Re: FCC ID RBT99061003

Applicant: PipeHawk Plc
Correspondence Reference Number: 26325
731 Confirmation Number: EA540369

Graph 1: NSA - Horizontal Polarization.

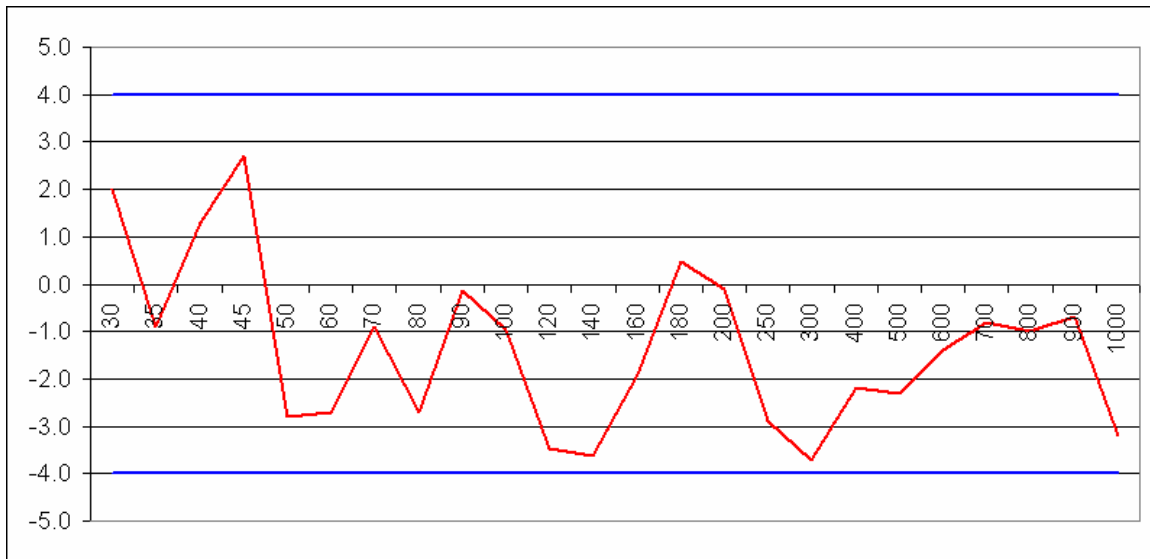
Quote: "1. You state that the ground plane is beneath the concrete slabs during tests. The photo's show this also. Remove these slabs and place a 20 inch bed of sand beneath the EUT. Do not put any ground plane beneath the device, remove it. Please retest. Please keep in mind the following and also past measurement issues."

Response: I can confirm that the EUT was placed on a 20 inch bed of sand. The bed of sand was placed on a protective layer of none conductive stone slabs. The slabs are used to protect the ground plane.

The ground plane is none removable and was used in line with the FCC's own guidelines as stipulated by the FCC in there First Report and Order Docket 98-153 Appendix F (7) which states "*Field strength measurements may be performed without the use of a ground plane; however, a factor of 4.7 dB must be added to the measurement results thus obtained.*" This implies a ground plane may be used without the addition of 4.7 dB.

The stone slabs serve the purpose of protection for the ground and have no direct effect on the final result. The measurement is made in compliance with C63.4 5.4 & 5.5. The site attenuation also fits within the specified criteria of C63.4 5.4.6.3 confirming the lack of influence the slabs have on the final result. Please see the following graphs showing the NSA.
